UNITED STATES PATENT AND TRADEMARK OFFICE

10/560,411

Office Action Summary	Application No. 10/560,411	Applicant(s) OEHMANN, ROLAND	
	Examiner Vinod D. Patel	Art Unit 3742

DETAILED ACTION

Fig. 5

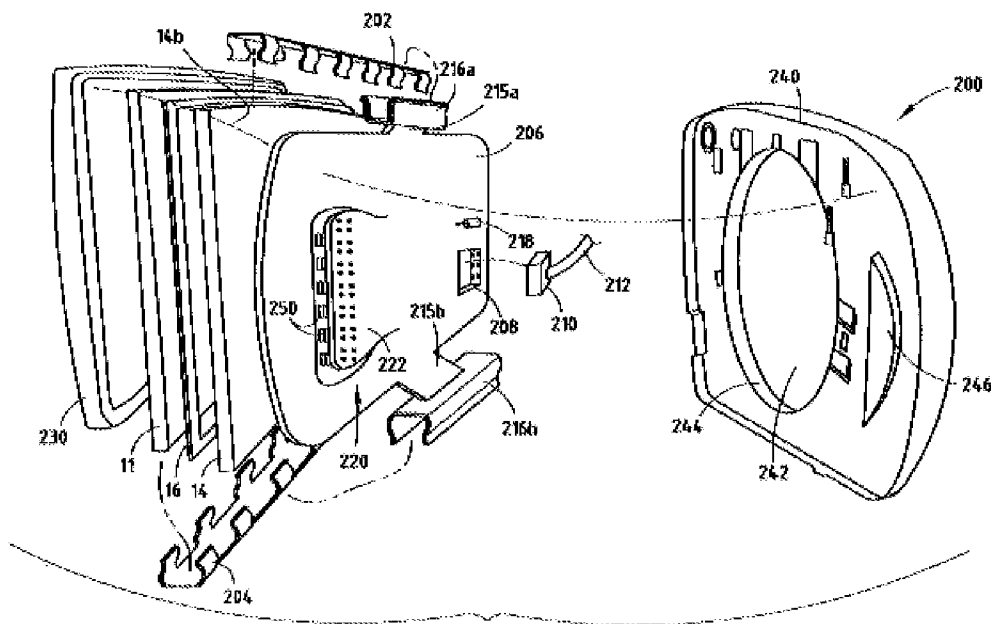
With respect to claim 4, the mirror glass is clamped in between a mirror glass support and a mirror glass frame, secured to said support, embracing the mirror glass on its front side as shown in Fig. 5.

With respect to claim 5, the mirror glass frame exhibits a ring-shaped hollow chamber leading along the edge of the mirror as shown in Figure 5.

With respect to claim 6, the tabs (215a) of the heating foil (206) equipped with said light source (220) are configured to exactly form-fit inside of the hollow chamber.
